**CITY OF KELOWNA
MEMORANDUM**

APPLICATION NO. Z05-0040 **APPLICANT:** Northland Properties Limited
(Scott Thomson)
AT: 2130 Harvey Ave. **OWNER:** Northland Properties Limited

PURPOSE: TO REZONE THE SUBJECT PROPERTY FROM THE C9LP – TOURIST COMMERCIAL (LIQUOR PRIMARY) ZONE TO THE C4LP – URBAN CENTRE COMMERCIAL (LIQUOR PRIMARY) ZONE TO ALLOW FOR AN EXPANSION TO THE EXISTING HOTEL.

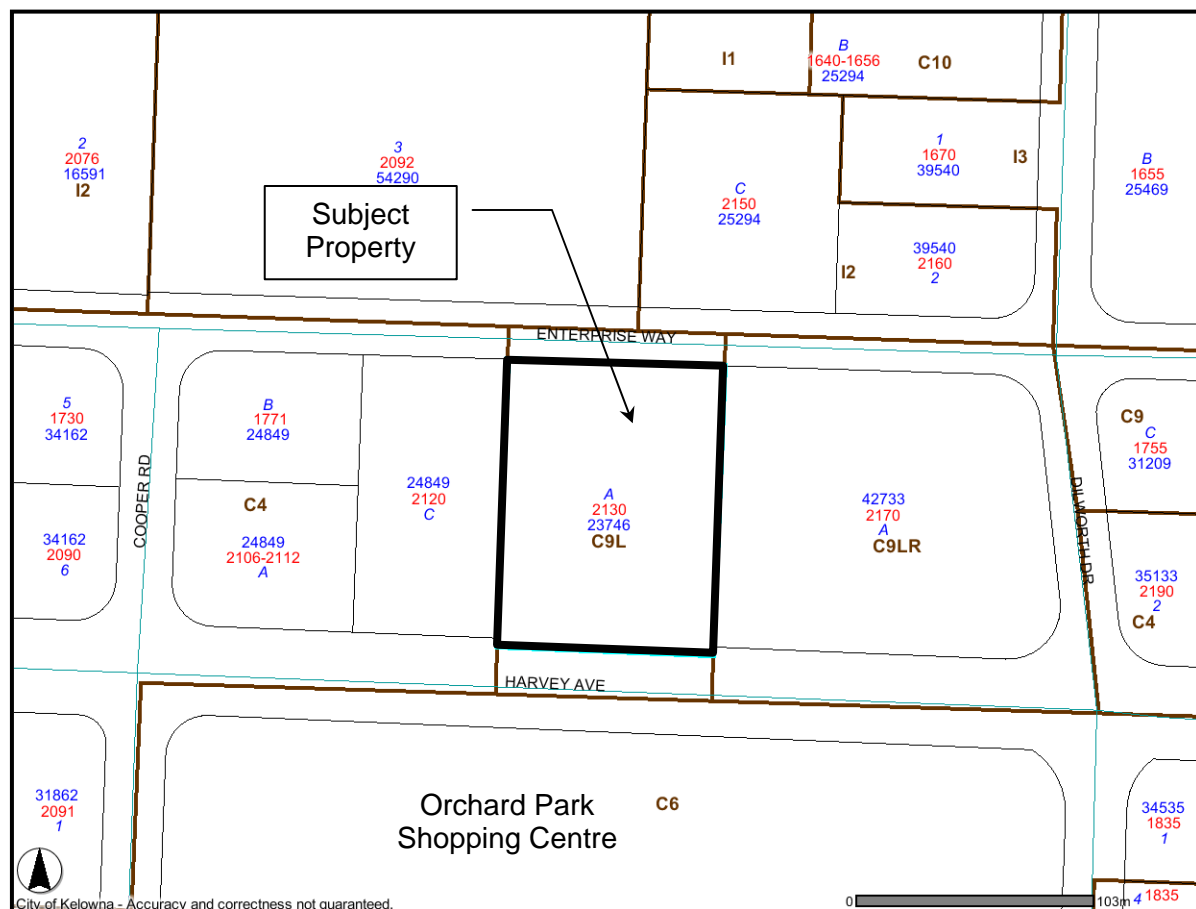
^B The Applicant has shown 203 parking spaces, but stall 71 does not meet the required width, due to that area also being used as a pedestrian walkway.

^C The Applicant will need to meet the parking requirement or resolve the parking shortfall through the development variance permit process.

^D The Applicant will be required to provide detail on the bicycle racks proposed for the south side of the new building.

^E The Applicant has applied to vary the loading requirements, providing one (1) loading space where five (5) are required.
